FINAL PRODUCT/PROCESS CHANGE NOTIFICATION #20498

Issue Date: 03-Jul-2014

TITLE: Cover Tape Material Change from Heat Seal to Cold Seal for Die Sales Products

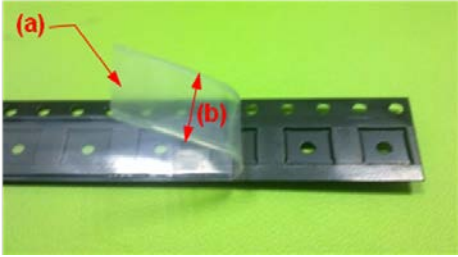
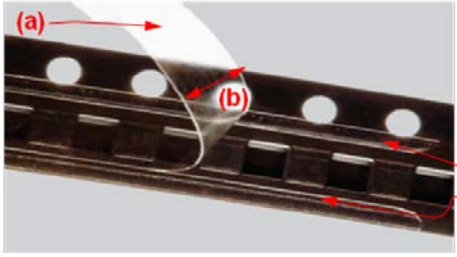
ON Semiconductor is pleased to announce the qualification of Cold Seal cover tape (3M part number UCT 2688A) for die sales products sold in Tape and Reel. Currently, these products are shipped in Tape and Reel with Heat Seal cover tape. This change is being made as part of ON Semiconductor's ongoing quality optimization efforts. The change to Cold Seal cover tape reduces the risk of die sticking to the cover tape.

Before	After
Supplier	3M	3M
Part #	2675	UCT 2688A
Type	Heat Seal	Cold Seal
	(a) Cover tape fully peel off from carrier tape (b) Cover tape with heat activated adhesive.	(a) Tearing effect on center of cover tape (b) Zero adhesive (c) Sealing path (left and right) remain on carrier tape, no glue transfer to customer machine / unit
